Crystal River Nuclear Plant  
Docket No. 50-302  
Operating License No. DPR-72

May 20, 2005  
3F0505-12

Subject: Crystal River Unit 3 – Revised Response to NRC Request for Additional Information Regarding Once-Through Steam Generator Tube Inservice Inspection Conducted During Refueling Outage 13

**Figure 1**

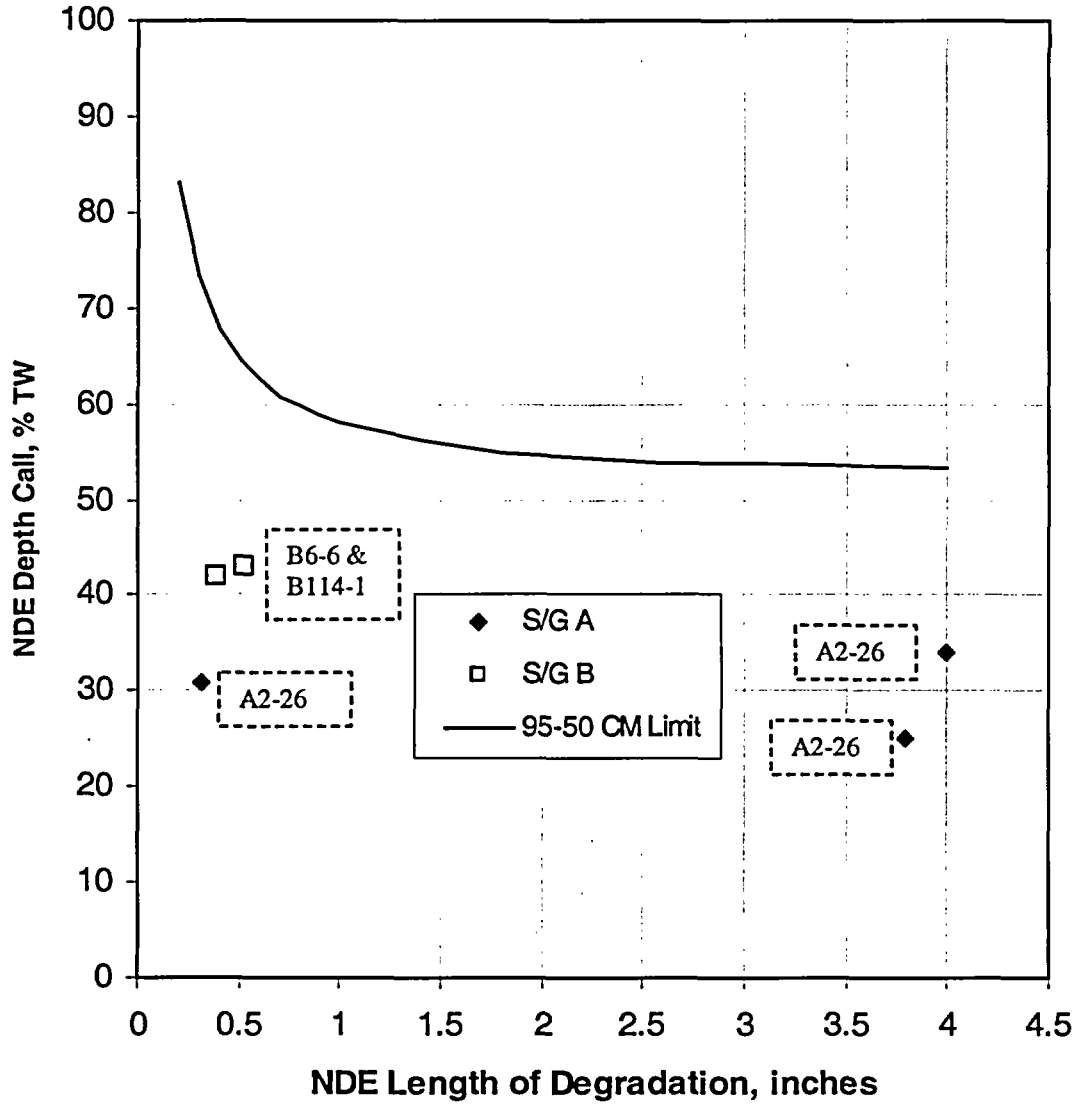
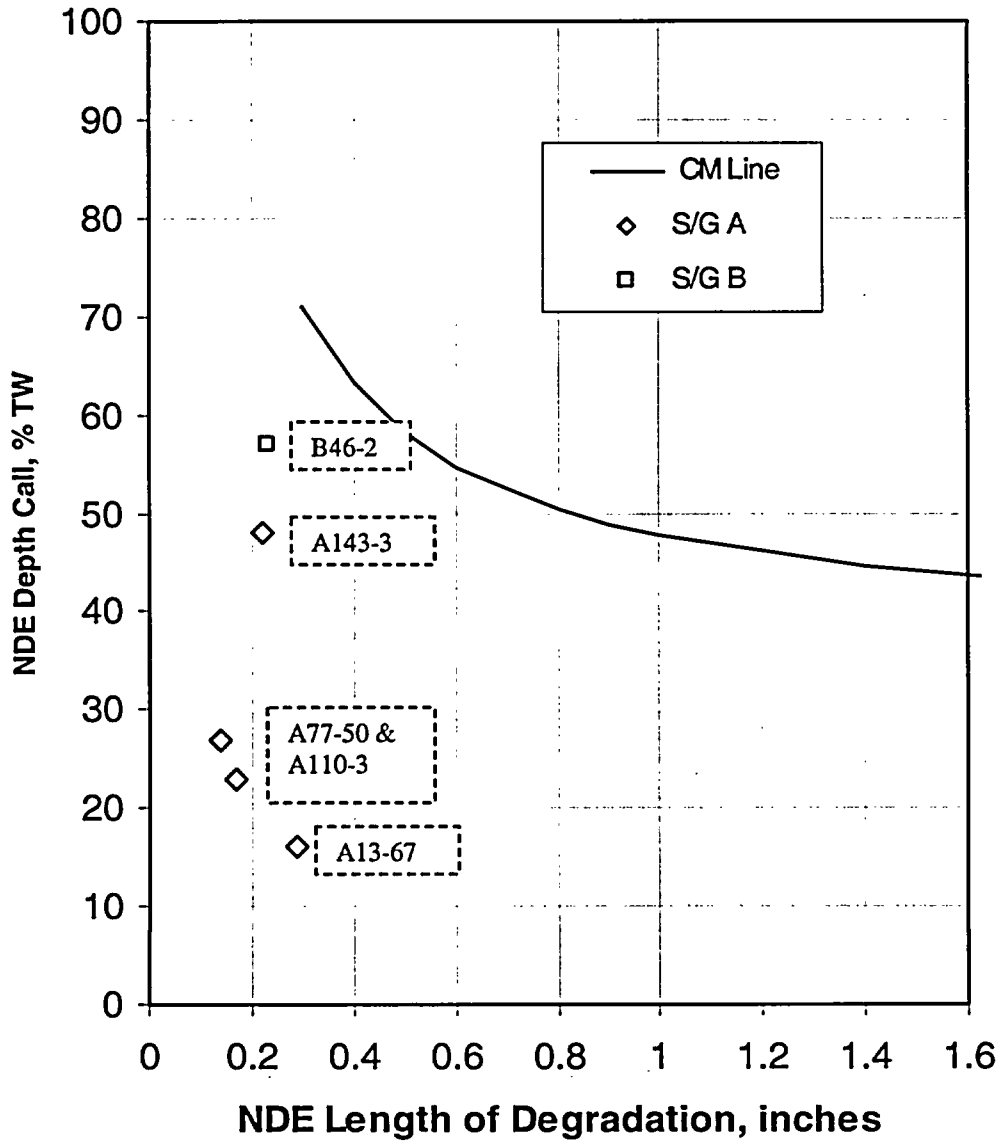
In the November 24, 2004, response to RAI question 3, the size of indications with the largest voltages was provided. Given that the largest voltage indication may not always correspond to the most severe indication (in terms of structural and leakage integrity), confirm that, in this case, the largest voltage indications were the most severe indications detected. In the future it would be beneficial to delineate the location of each imperfection based on whether the indications are in the original roll transition, the original roll expanded region (other than the transition and the tube end), the re-roll upper or lower roll transition, the re-roll expanded region, the unexpanded portion of tube in the tubesheet region (not between re-rolls), the free span portion of the tube (outside the tubesheet) etc. In addition, it would be beneficial to specify the number of re-rolls (if any) were in the tube at the time of the inspection if the imperfections are in the tubesheet region.

The response to RAI question 3 from the November 24, 2004 letter provided a table of the eddy current indications that identified the largest signal voltage for a given type of Non-destructive Examination (NDE) indication. This table provided a list of many of the largest percent through-wall indications found during the inspection. The response also provided a separate list of indications in each OTSG excluding indications near the cladding, first span intergranular attack and wear. However, not all of the largest voltage indications are the most severe when compared to a condition monitoring assessment for structural and leakage evaluation. As requested, the most limiting indications based on the structural and leakage assessment are identified in the table and Figures 1 and 2 below. Where a given type of NDE indication is not represented in the table, it is because that type of indication was not considered the most limiting based on the structural and leakage assessment. To provide additional flaw information, the locations of the imperfections are identified by OTSG landmark.

The choice of the largest indications for the A-OTSG and B-OTSG is from the 13R Condition Monitoring (CM) assessment. For condition monitoring, degradation dimensions are inferred from NDE measurements. Therefore, the condition monitoring limit curves in Figures 1 & 2 include NDE sizing uncertainties as well as material property variation and burst pressure calculation uncertainties. NDE readings which plot under the Condition Monitoring Limit curve demonstrate at least a 0.95 probability at 50% confidence that the burst pressure meets or exceeds a value of 3 Delta P. Indications with NDE measured lengths and depths at or below the Condition Monitoring Limit curve meet the required deterministic structural performance criteria for minimum degraded tube burst pressure. Each of the indications was compared to the CM criteria which are established for CR3. The leakage assessment for these indications was also acceptable.

### 13R Largest Indications For Structural and Leakage Integrity

**Cross Sectional View of an OTSG Tubing Sleeve at Crystal River Unit 3**

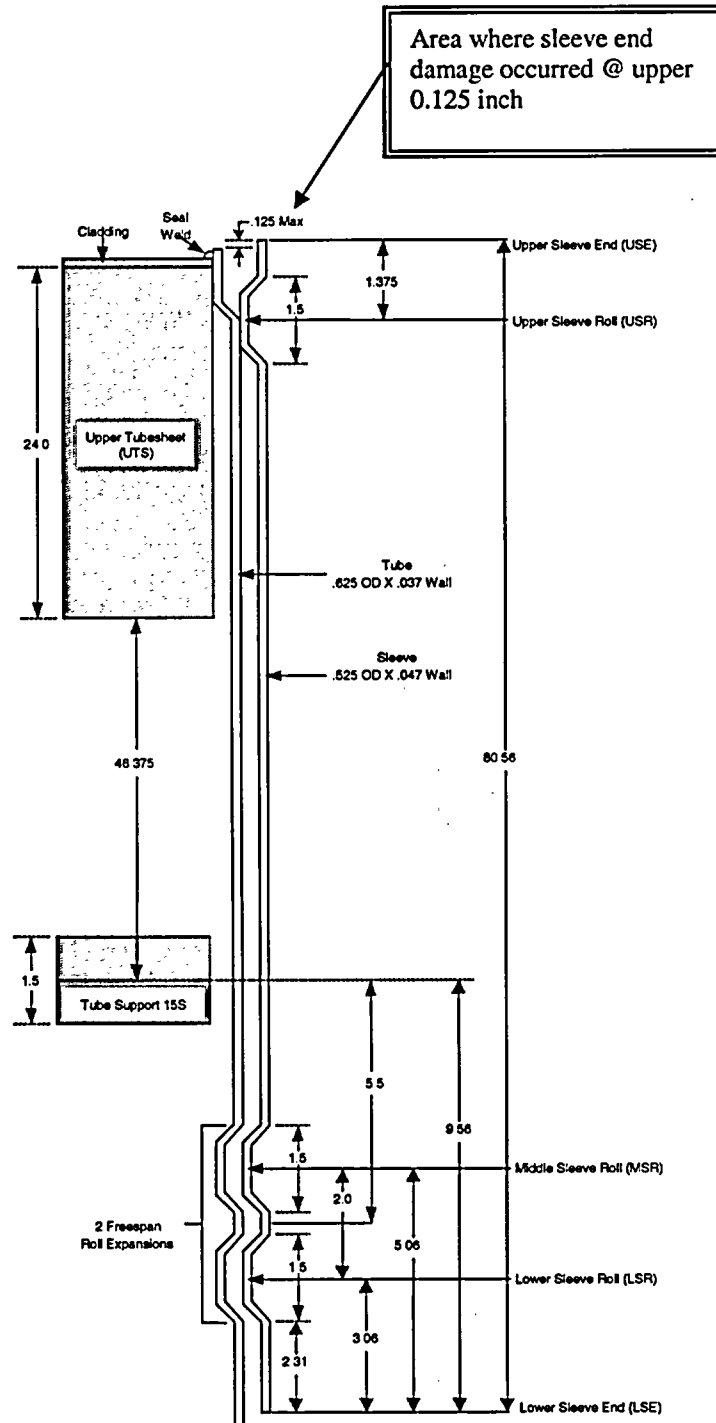
- c) Given that the upper sleeve joint is a mechanical joint, discuss how you confirmed that the obstruction did not result in a weakening of the joint (i.e., pulling of the sleeve away from the parent tube) such that the sleeve could not meet its original design criteria. Provide the extent of the obstruction and the technical basis for your conclusion.

- d) Although no rejectable flaw-like signals were identified during the inspection of the portion of the sleeve that could be inspected, discuss whether an obstruction in another sleeved tube could have weakened the joint such that the sleeve could no longer meet its original design criteria.

Visual inspection of the sleeve ends showed that the ends were not pulled away from the parent tube and the sleeve opening was essentially round indicating only minor impacts from above. The sleeve end was only slightly deformed to the point where the eddy current probe could not

enter and traverse the sleeve. For example, there were several other sleeves that originally could not pass a probe (NDE Code OBS) which later had the sleeve ends opened using a tube end repair tool. Once the tube ends were opened, every sleeve was inspected and no defects were identified in any sleeve or rolled joint. These four sleeves/tubes were only plugged because the original tube-end repair tool had to be replaced and a new tool was not available in a timely manner. In addition, the original sleeve qualification testing (BAW-2120P, Steam Generator Tube Slewing) included axial load cycling in excess of the possible impact loading from loose parts. The qualification testing results, along with the minimal damage to the sleeve end, was the technical basis for determining the sleeve and rolled joints were still acceptable.

As explained in response 5a), the obstruction was tube end damage and not foreign material. The tubes and upper sleeve ends extend above the tubesheet approximately 0.187 inch. The upper sleeve rolled joint is centered approximately 1.375 inch below the tube end. Therefore, sleeve end damage is not expected to weaken the joint such that the sleeve could no longer meet its original design criteria. A drawing of a typical sleeve is attached.
